Subject: Mt. Carmel Grove City Medical Center  
Development plan Amendment Application  
Control No.: 201603110014  
EMH&T Job No.: 2013-1538

We have summarized the comments received from City of Grove City on March 23, 2016 and provided our response. The plans have been updated to address the comments as follows:

MOUNT CARMEL  
Grove City  
Phase II  
Development Plan

**C2.2**

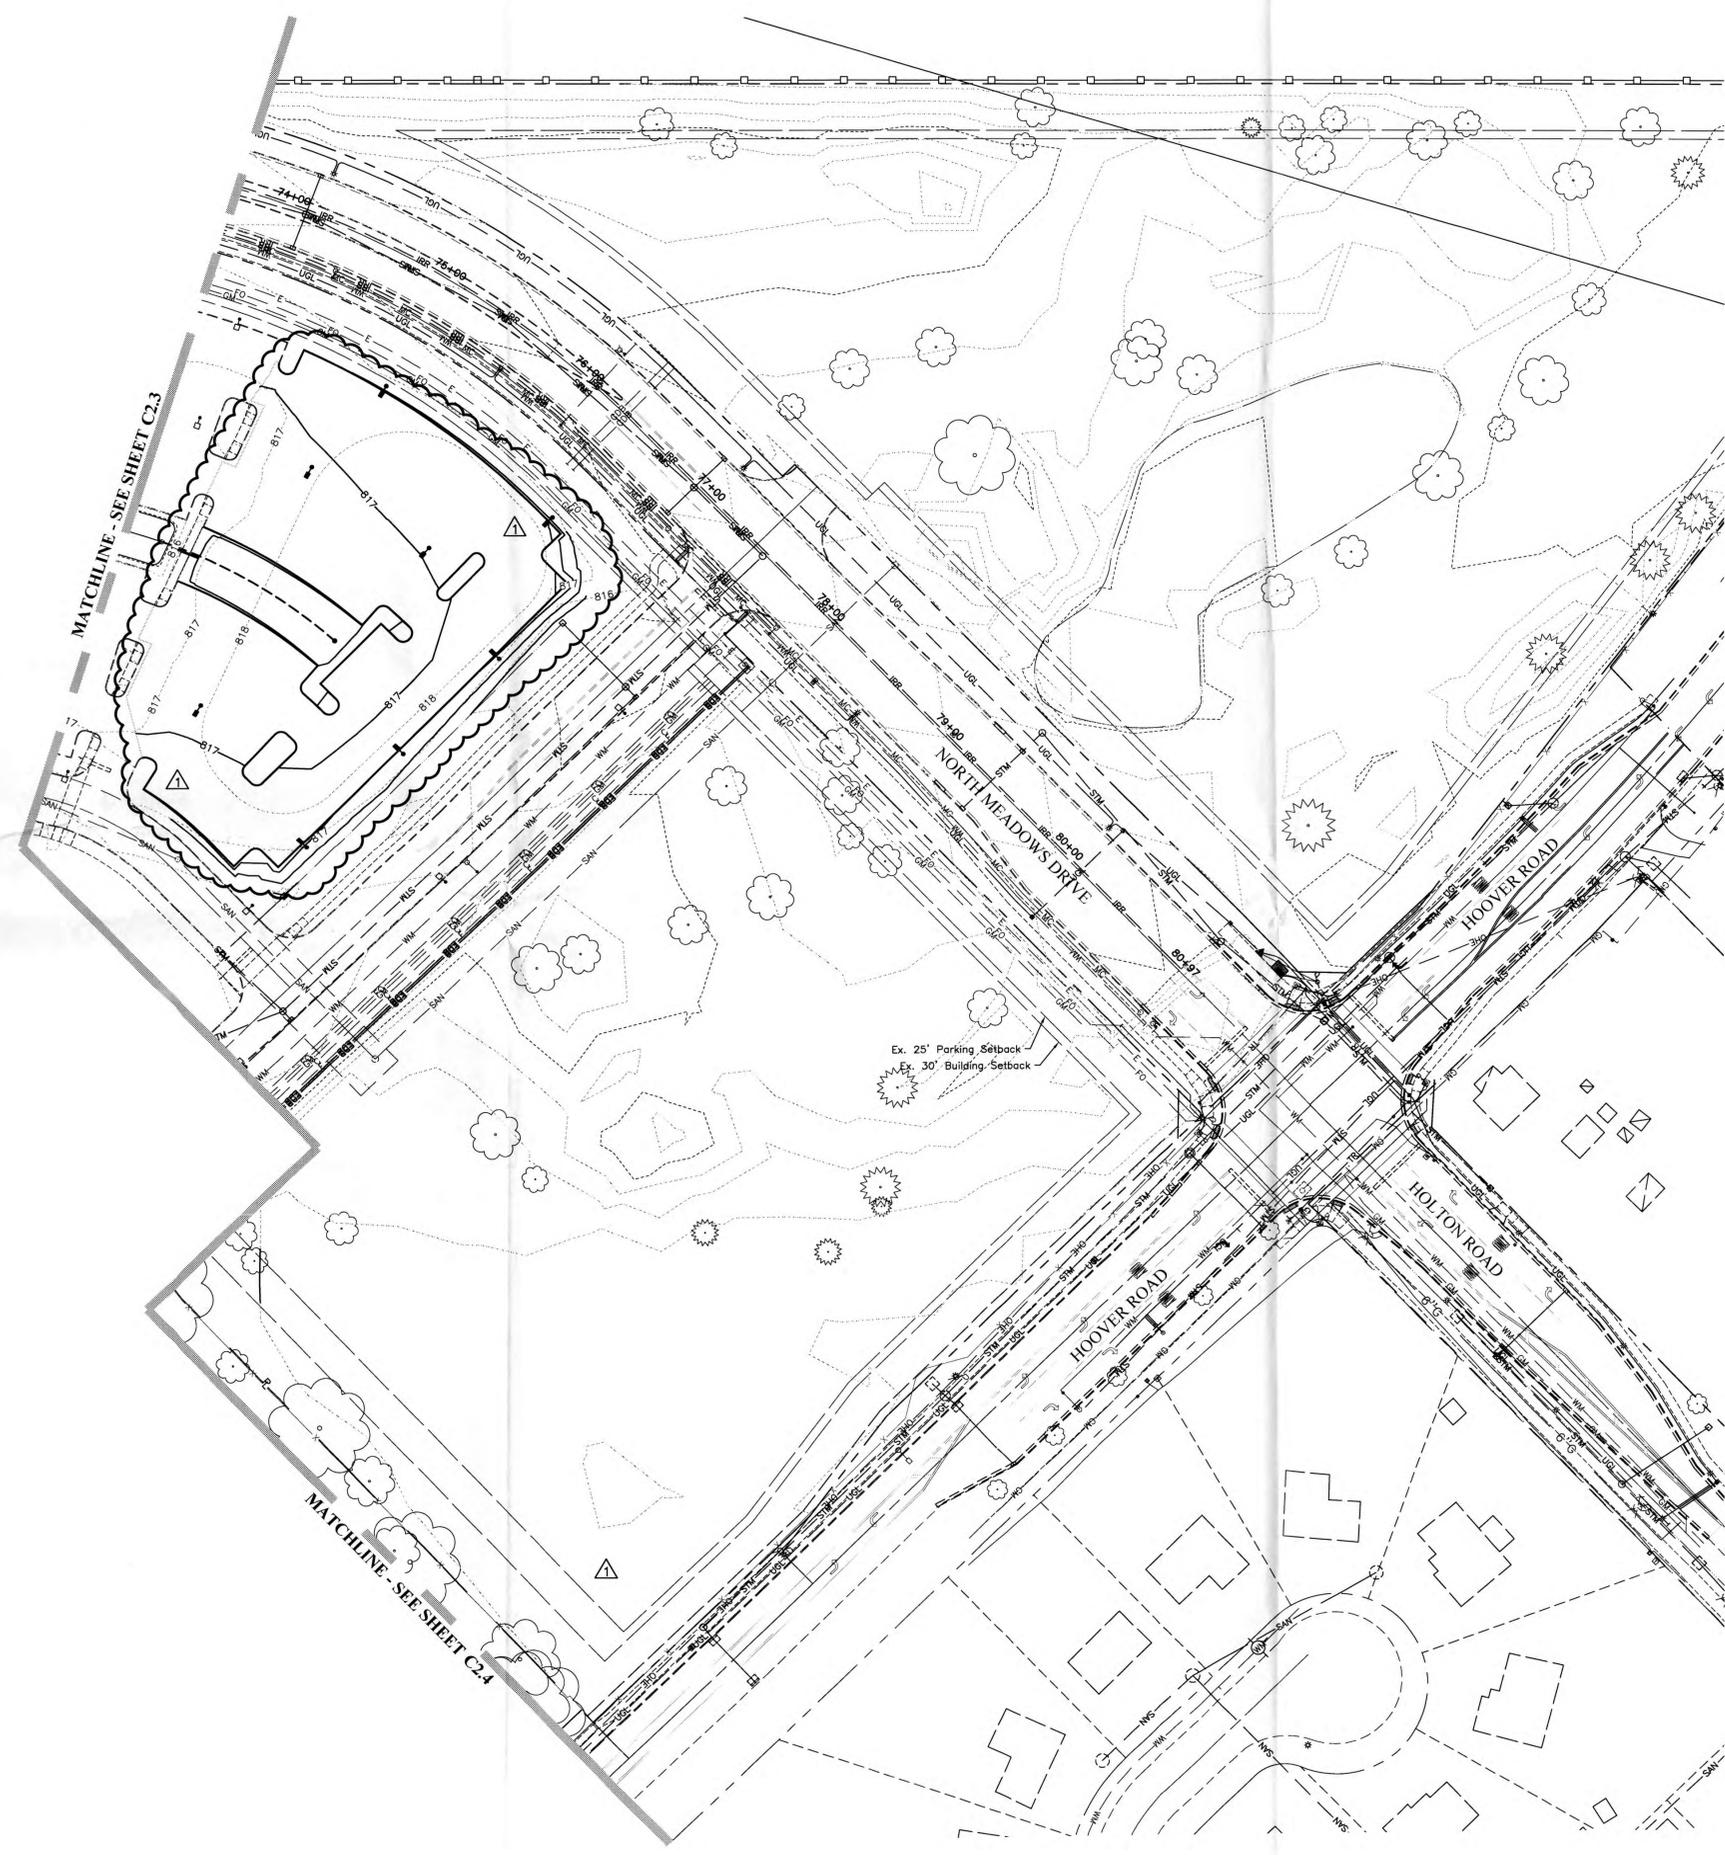
18. The detention basin shown next to the proposed fill area will not be deeper than the required 5' maximum from the ground level adjacent to the pond to the normal water surface elevation. This will give the appearance of a very deep drop to the pond.

**Response: A 20' bench between the fill slope and the pond slope is being maintained for accessibility around the pond. The Owner understands that future building improvements on the fill area will be subject to development standards in place at that time.**

Grading  
Plan-Northeast  
**C2.3A**  
PROJECT: 20131538  
DATE: FEBRUARY 29, 2016

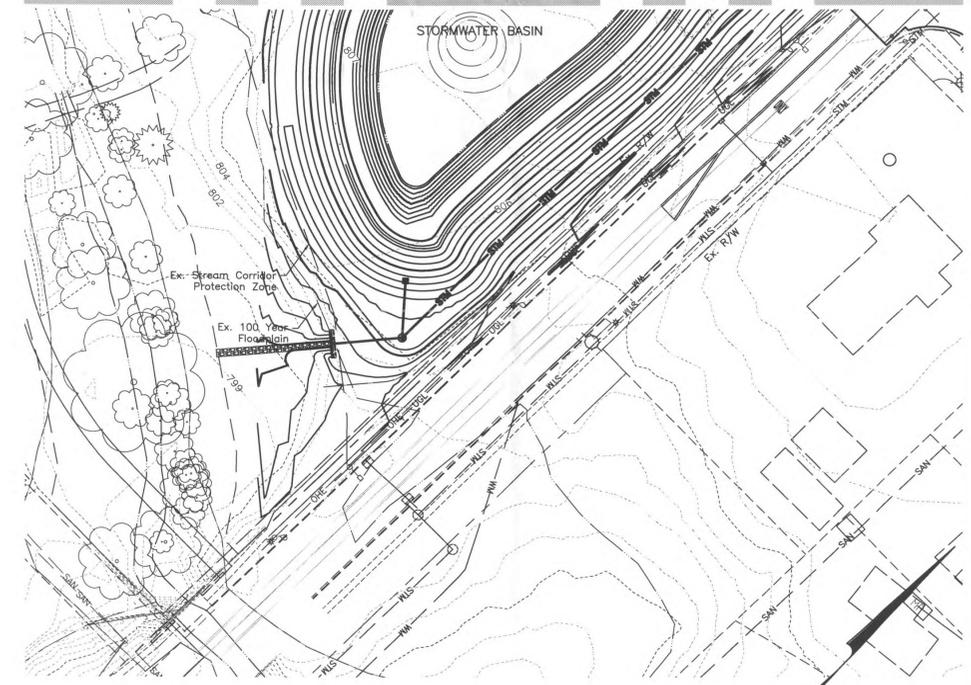
19. Proposed parking lot addition at the NE corner of the existing parking area appears to show a dry detention basin? Please clarify.

**Response: The landscape island at the NE parking expansion is intended to look like a continuation of the plantings and landscape present in the phase 1 lot, with the exception that the new landscaping will not contain a bioswale and will not have depressed grading present in the phase 1 bioswale.**

**C2.4**

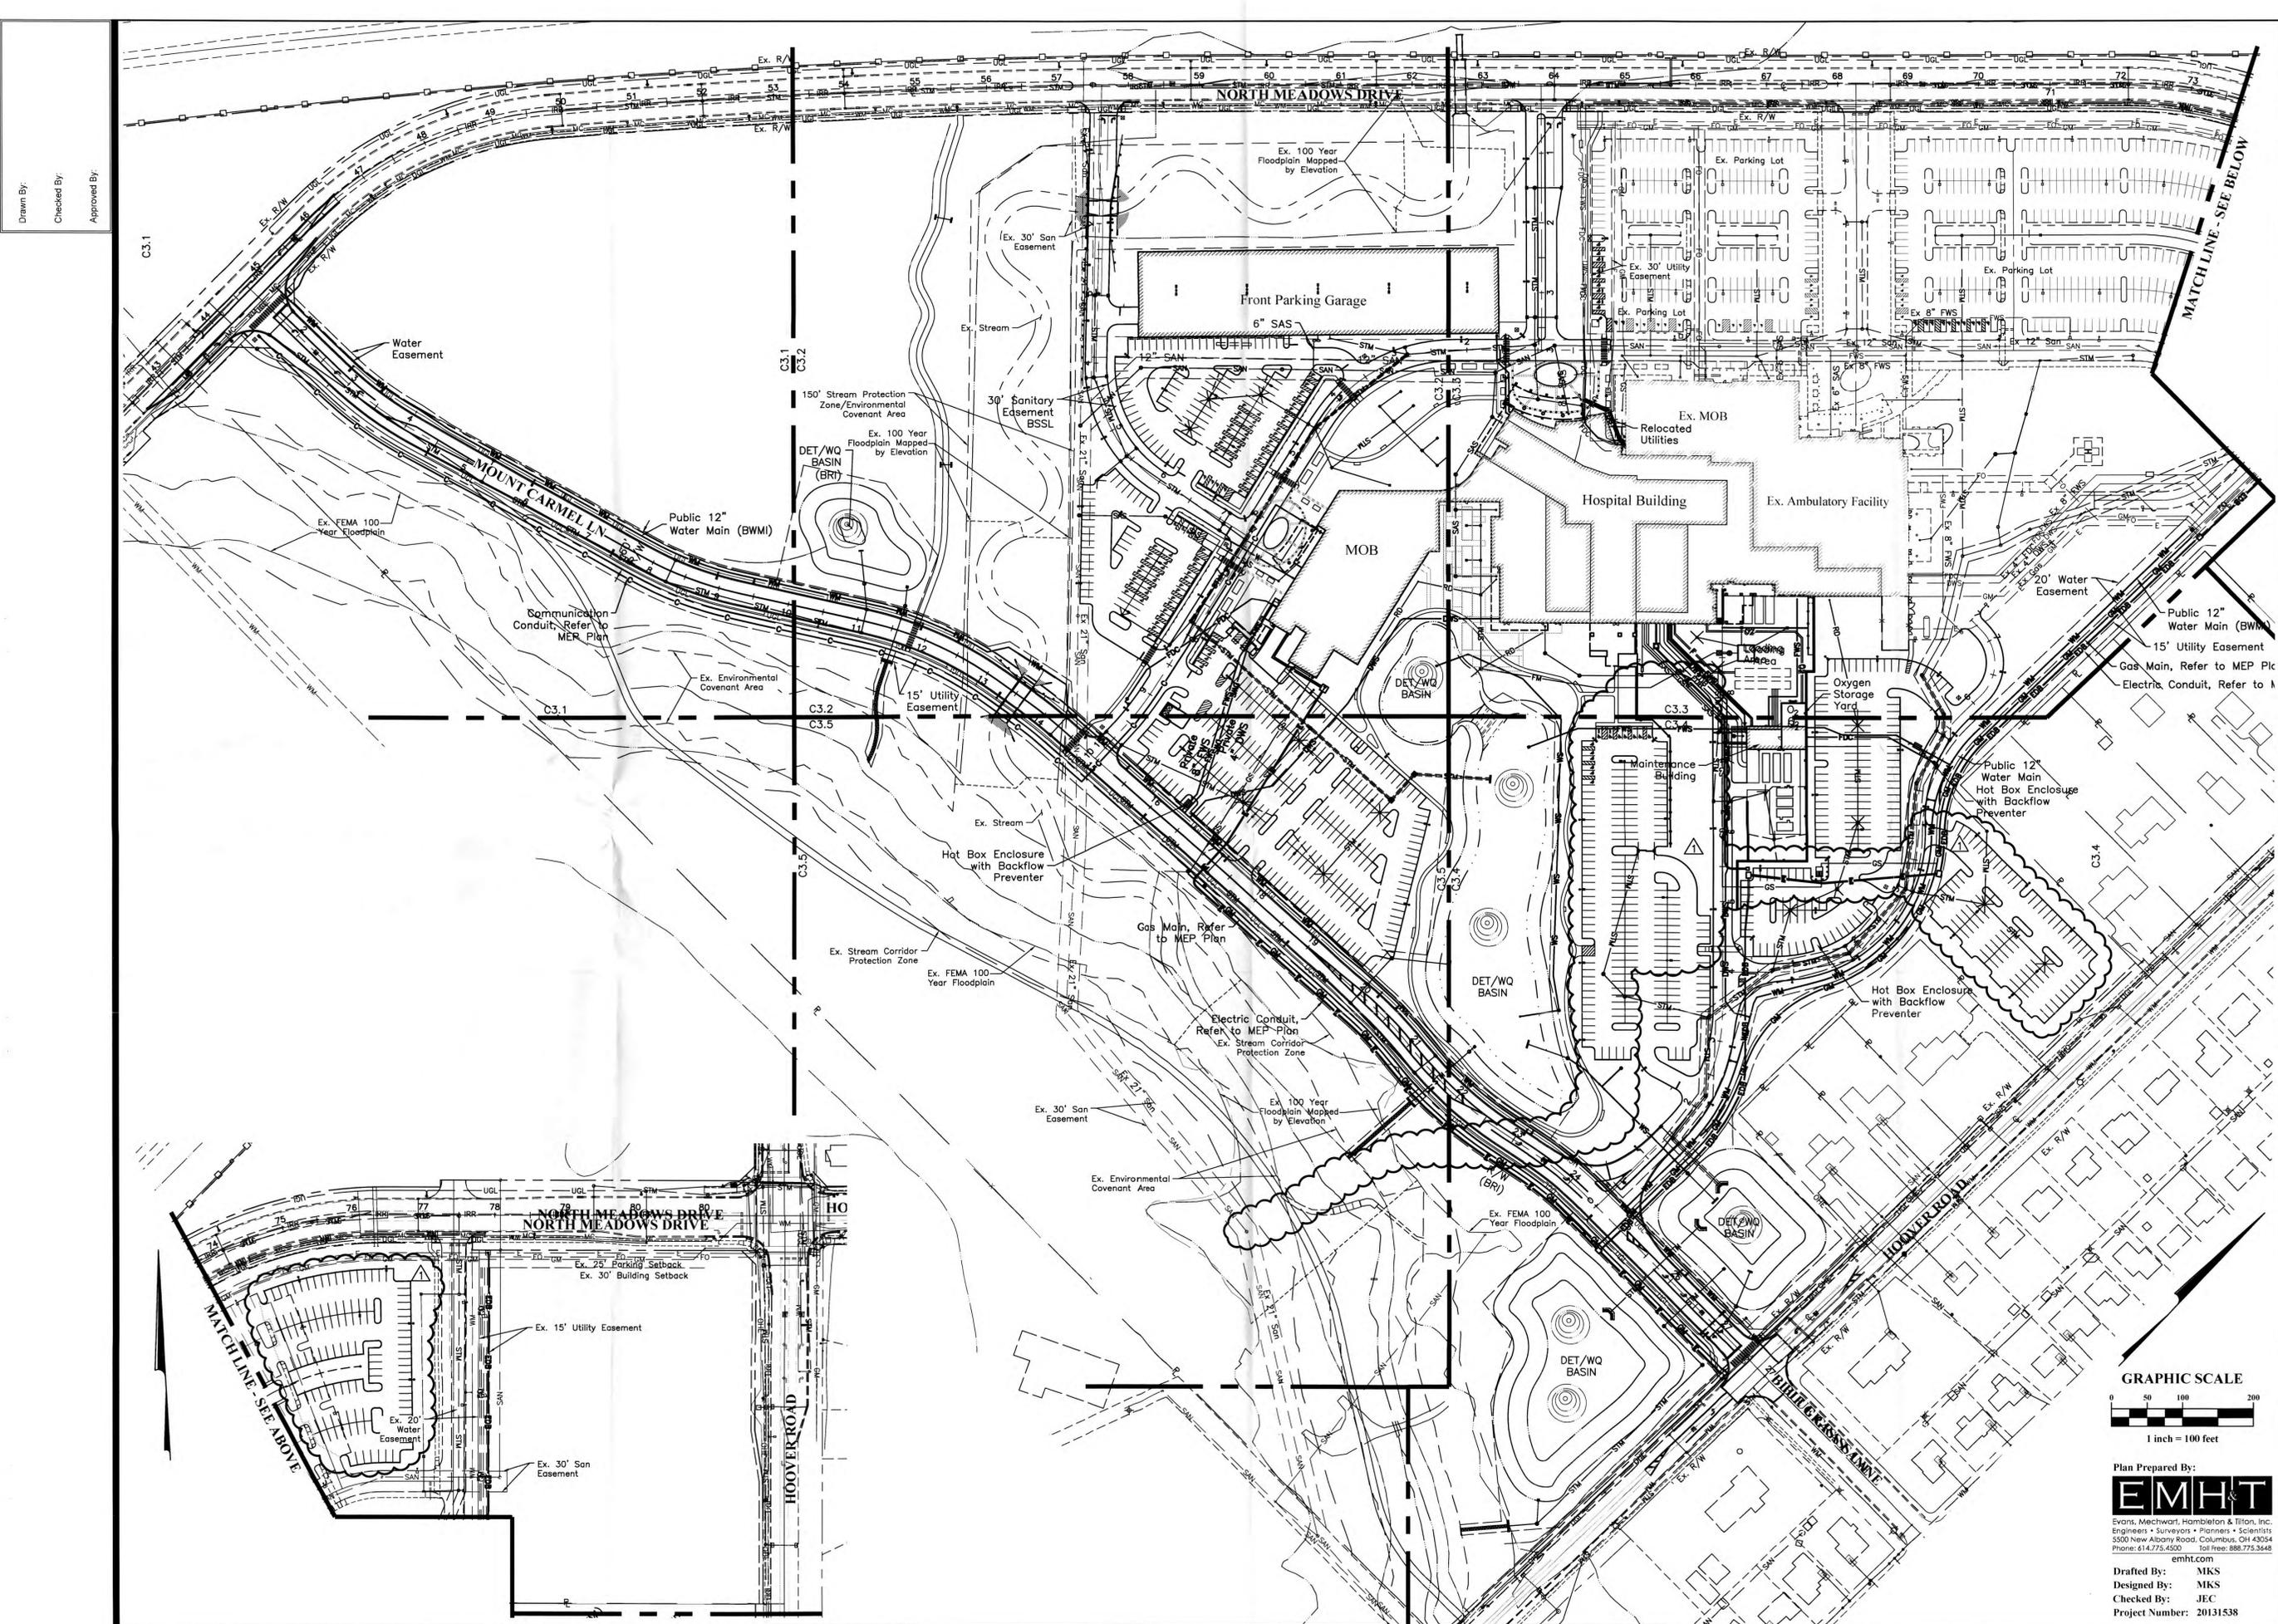
20. Proposed parking lot alongside the residences on Hoover Road should be required to use cut off style lighting to minimize impact to existing residences.

**Response: Proposed lighting fixture cut sheets will be provided electronically as part of this resubmittal.**

**C3.0**

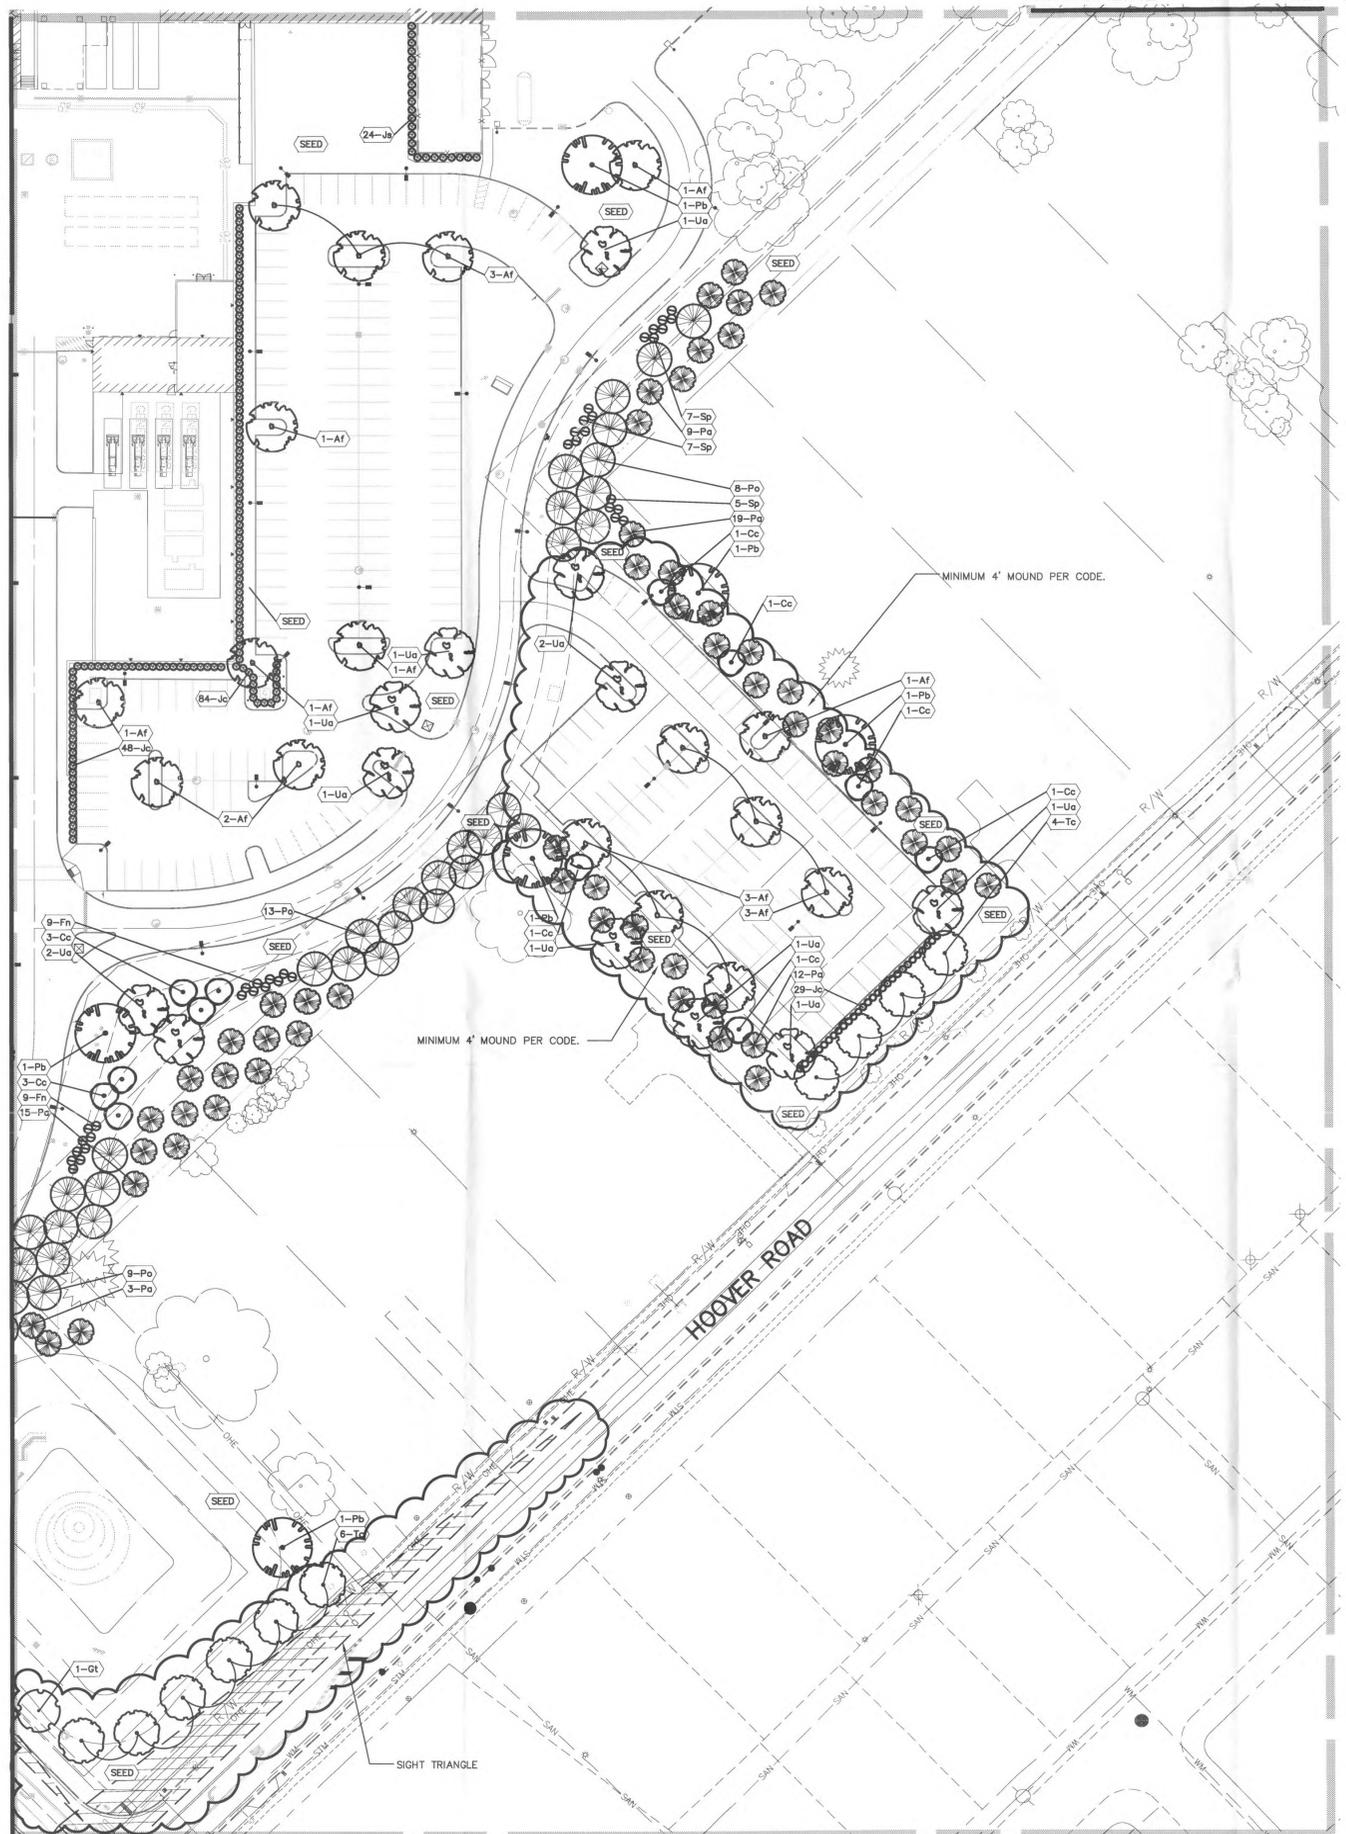
21. No details provided for utility plan changes.

**Response: The clouding on sheet C3.0 are intended to indicate the removal of the rear parking garage and associated water and sanitary utilities, the removal of the second (auxiliary fire service tap to the hospital), and the relocation of proposed gas and electric service connection points for the hospital.**
